Our Ref: 18117

13 June 2019

**RE: DUNMORE LAKES SAND EXTRACTION PROJECT
MODIFICATION TO DA 195-8-2004 MOD 2
RESPONSE TO ROADS & MARITIME SERVICES REQUEST FOR FURTHER INFORMATION
ADDITIONAL INTERSECTION MODELLING FOR PRINCES HWY & RIVERSIDE DRIVE
RMS REF : STH11/00218/15**

Figure 1: Location of Additional Intersection Operation Assessment and Surveyed Peak Hour Traffic Flows

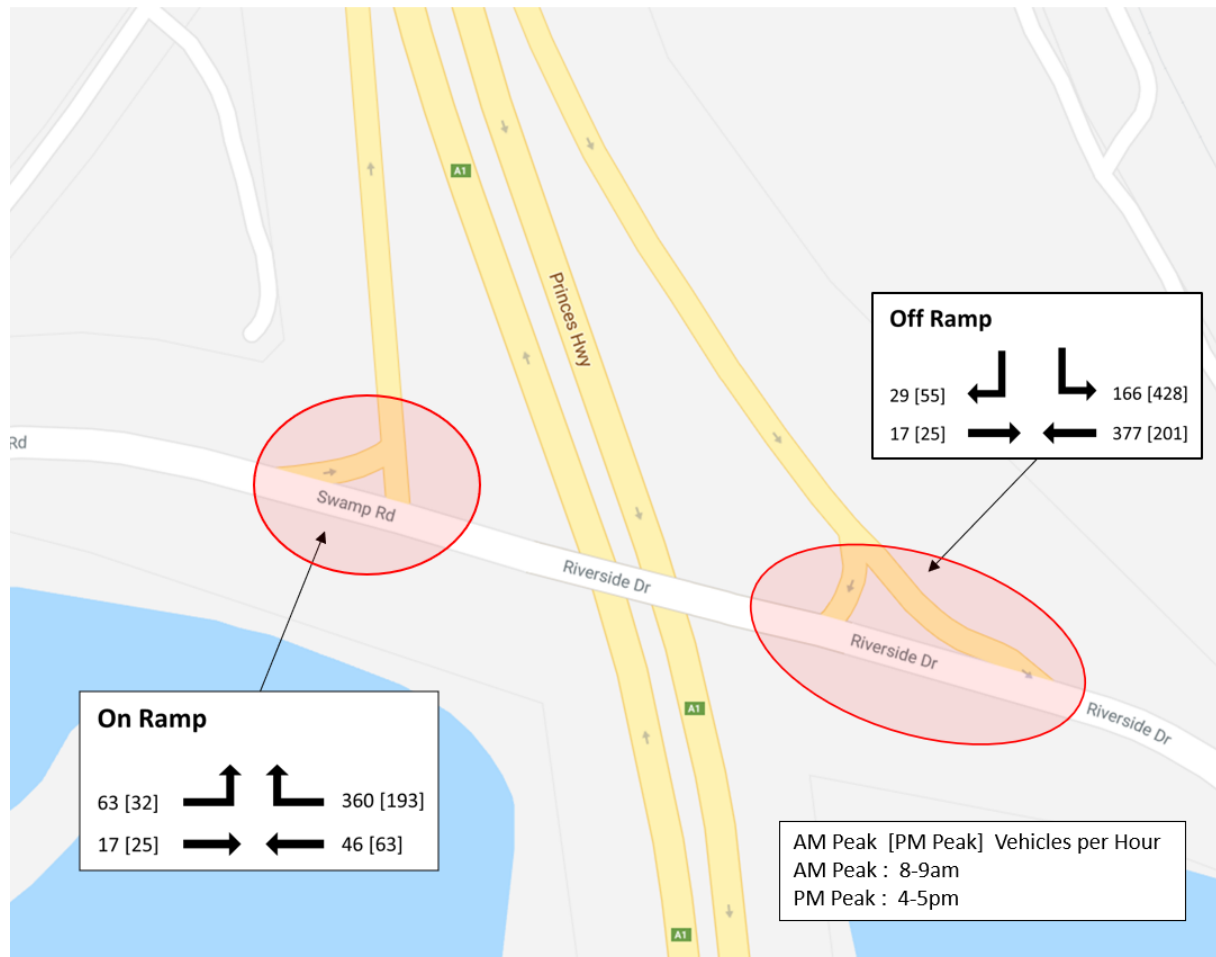
Locations for Further Intersection Operation Assessment

Consultation between RMS and TPPP (6 June 2019) has confirmed that the locations where further intersection operation assessment is required are as follows:

- Princes Highway Off Ramp / Riverside Drive
- Princes Highway On Ramp / Riverside Drive

For clarity, these locations are shown in Figure 1 below.

Peak AM and PM period vehicle turning movement counts were undertaken at the intersections on Thursday 6 June 2019.

The surveyed peak flows are presented in Figure 1. The surveyed peak period flows were used to generate to “Base Conditions” models as presented in this further assessment.

Figure 3: Scenario 1 – Base 2028 Level of Service Modelling Results

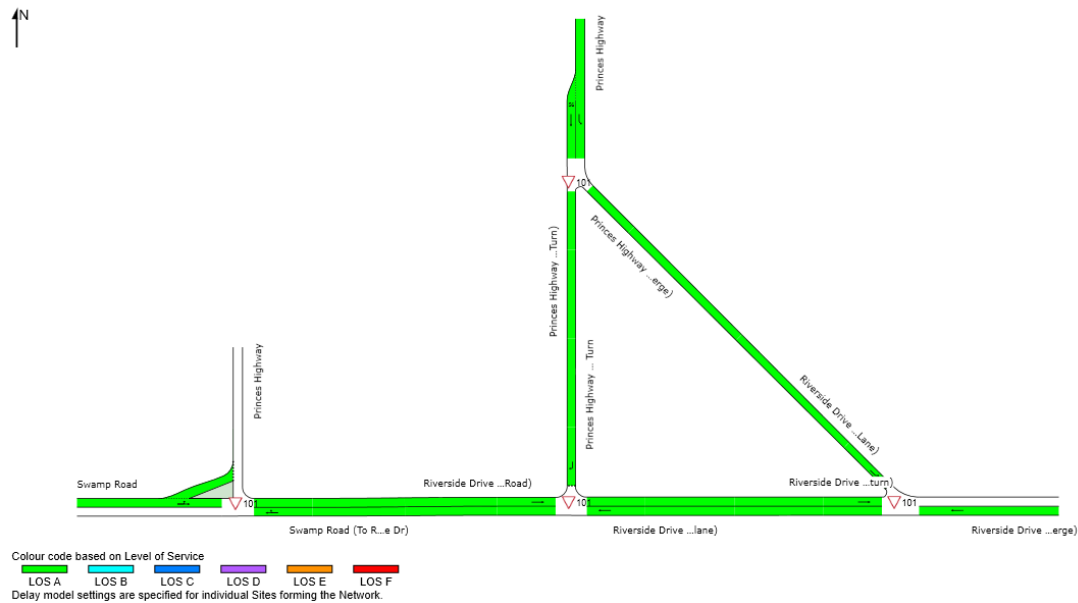
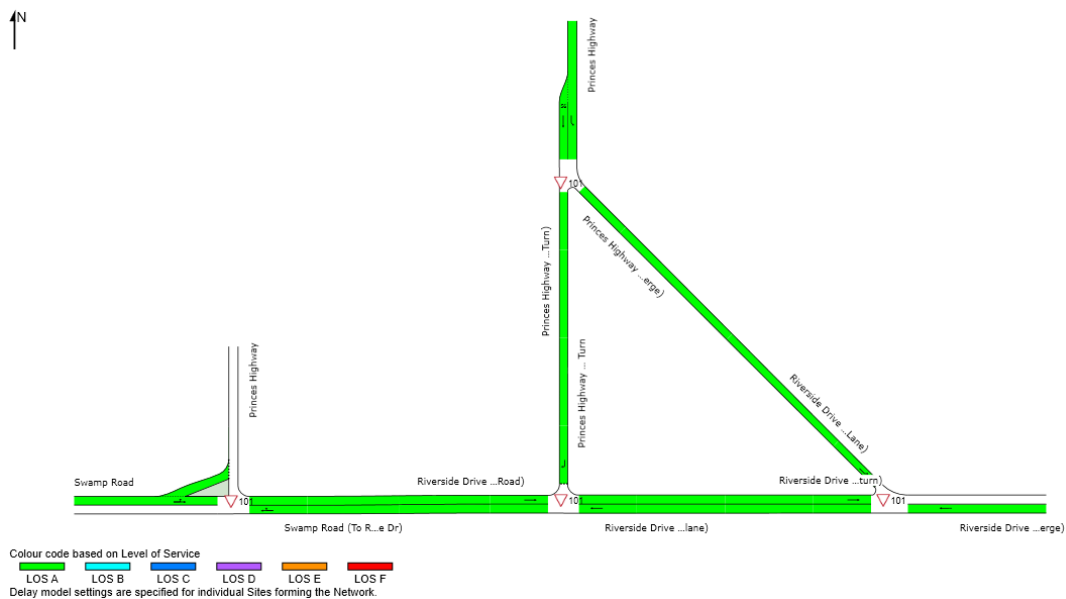
Please find presented herein, additional information prepared in response to Roads & Maritime Services (RMS) request for further information as set out in RMS correspondence dated 27 May 2019.

The Level of Service (LoS) results of the SIDRA modelling are presented in Figure 3 and Figure 4. Average Level of Delay results are summarised in Table 1.

The results indicate that the intersections at the on and off ramps intersections between the Princes Highway and Riverside Drive will operate satisfactorily with and without additional truck traffic generated by the importation of VENM to the Stage 5 site in 2028.
